NOT APPROVED

S278 DRAWING/DESIGN IS STILL 'SUBJECT TO LHA APPROVAL'
YOU ARE ADVISED TO MAKE DUE ALLOWANCE

Client			
Project Name	EASTERGATE, FONTWELL		
Title	SECTION 278 GENERAL ARRANGEMENT		
Project Phase	DETAILED DESIGN		
Checked By	Checked Date	Drawn By	Drawn Date
RW	12.05.21	CL	12.05.21
Client Drawing No.		Scale	
	-	1:200	(AT A1 SIZE)
PBA Drawing No.		Revision	
108.5009.101		B

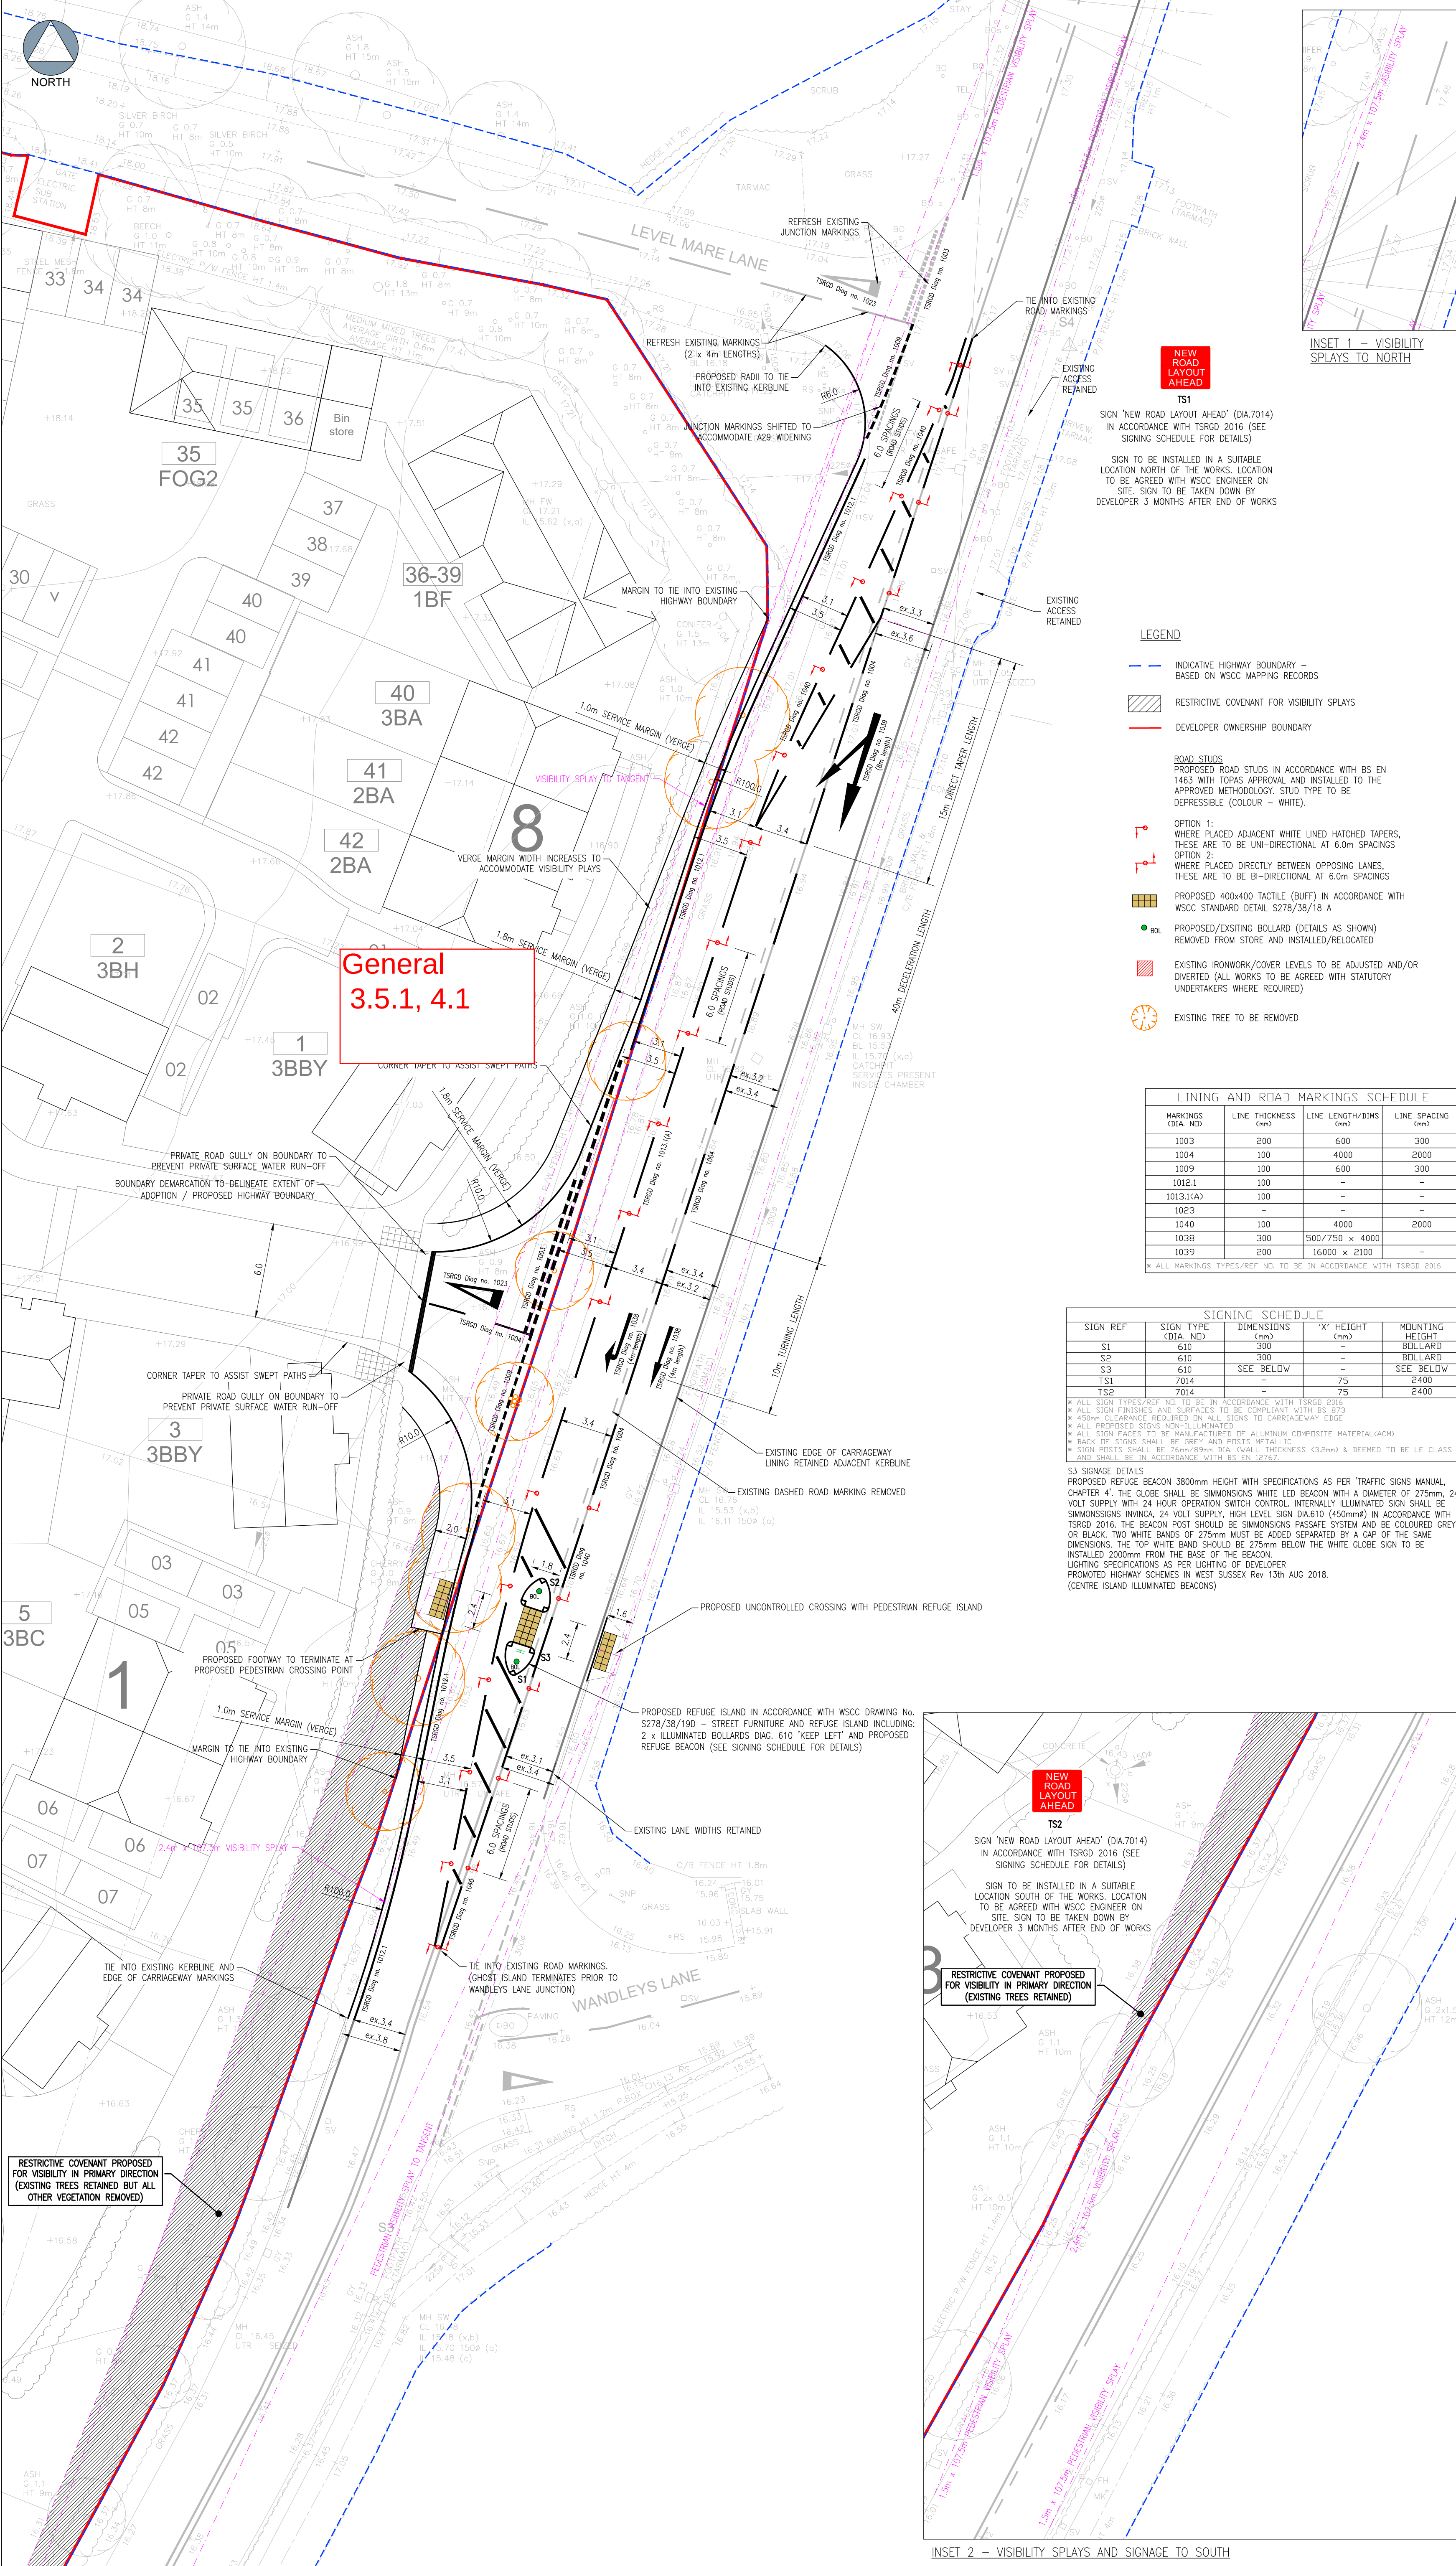
B	RESPONSE TO WSCC DR01 COMMENTS: • DOUBLE LINING CHANGED TO DASHED • ROAD STUDS UPDATED	22.07.21	CL	RW
A	BOUNDARY DEMARCATION UPDATED	25.05.21	CL	RW
Rev	Description	Date	By	Chkd
